**Presentation from
Julian Aherne**

**BWXT Nuclear Energy Canada Inc.,
Toronto and Peterborough Facilities**

Application for the renewal of the licence for
Toronto and Peterborough facilities

Commission Public Hearing

iemp | independent environmental monitoring program

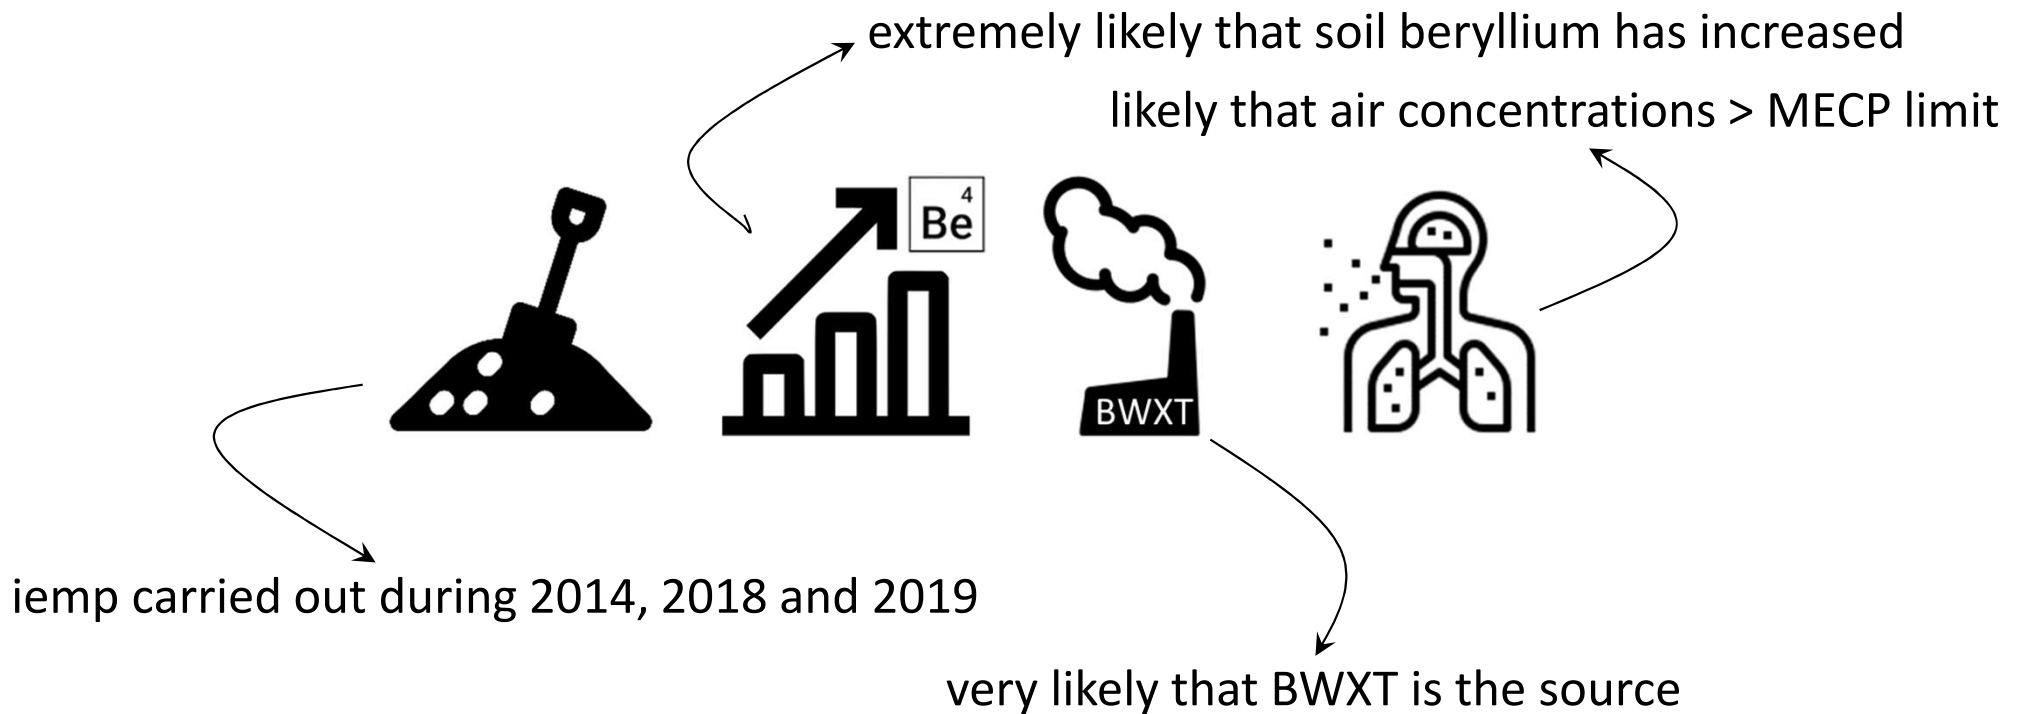
recommendation: use the IEMP data and ensure greater accuracy in reporting

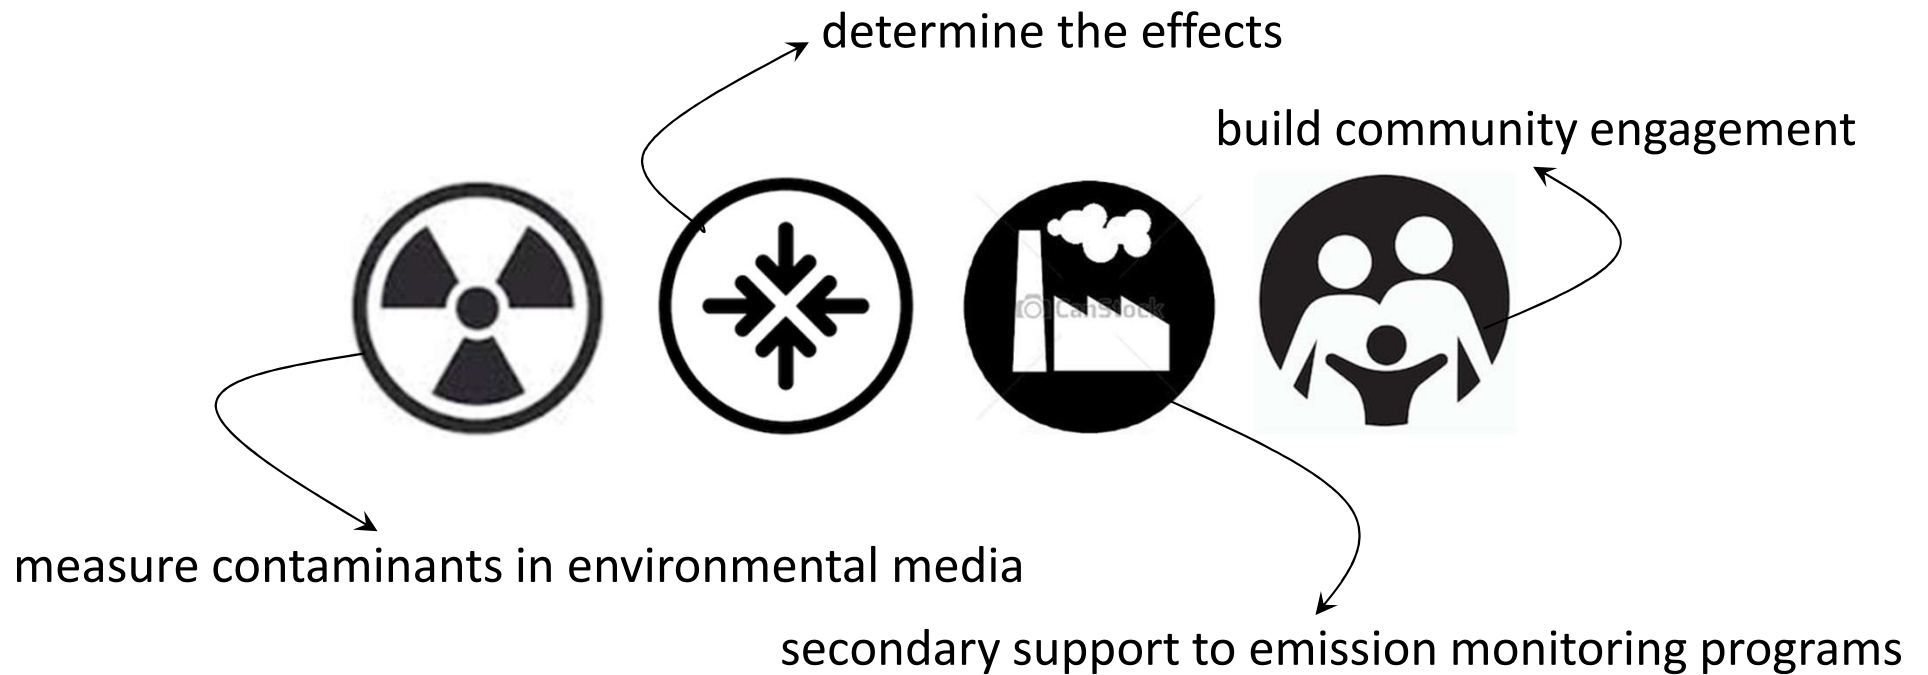
recommendation: based on the observed IEMP data it is inappropriate to proceed with the licence renewal application
